### 3.4 Instrumentation and Control

The information in this section of the reference ABWR DCD, including all subsections, tables, and figures, is incorporated by reference with the following departure.

STD DEP T1 3.4-1 (Figure 3.4a, Figure 3.4b, Figure 3.4c)

**Figure 3.4a Safety System Logic and Control (SSLC) Control Interface Diagram**

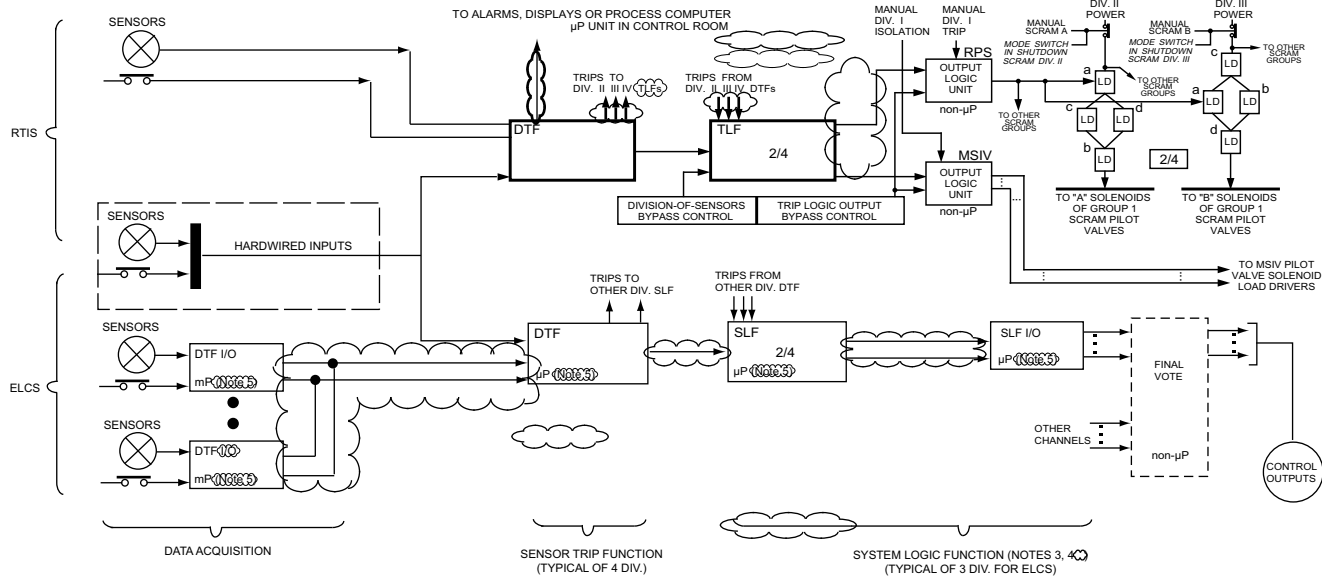
safety-related portions of the Neutron Monitoring System (NMS), the Containment Atmospheric Monitoring System (CAMS) and the radiation monitoring systems. The relationship between SSLC and systems for plant protection is shown in Figure 3.4a.

**Figure 3.4b Safety System Logic & Control Block Diagram**

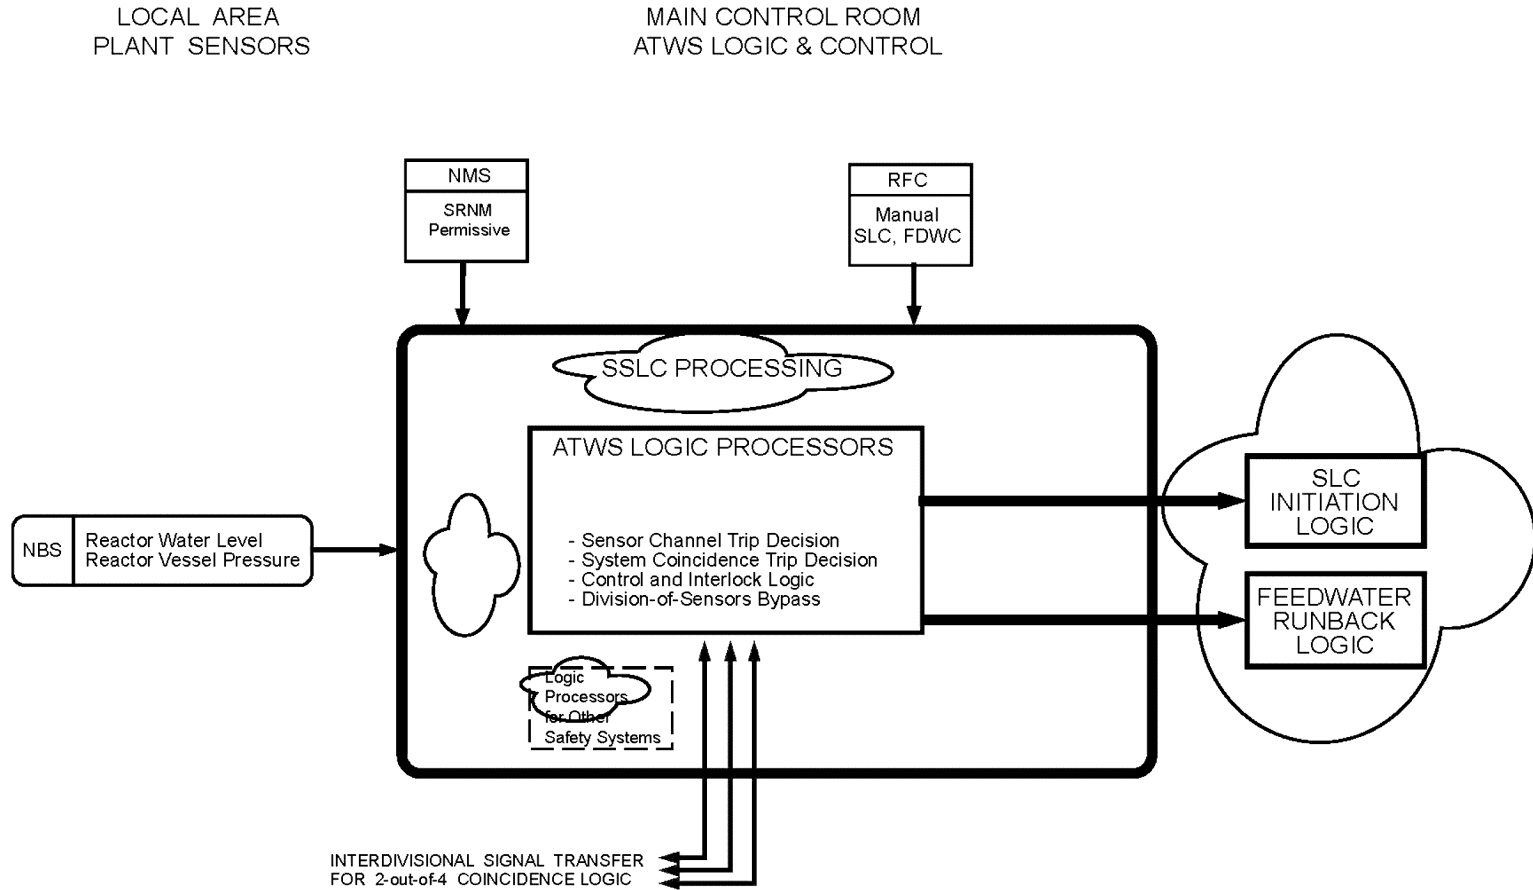
~~The basic hardware functional configuration for one division of SSLC is shown in Figure 3.4b. Each division runs independently (i.e., asynchronously) with respect to the other divisions. The following steps describe the processing sequence and associated function descriptions for incoming sensor signals and outgoing control signals. These steps are performed simultaneously and independently in each of the four divisions:~~
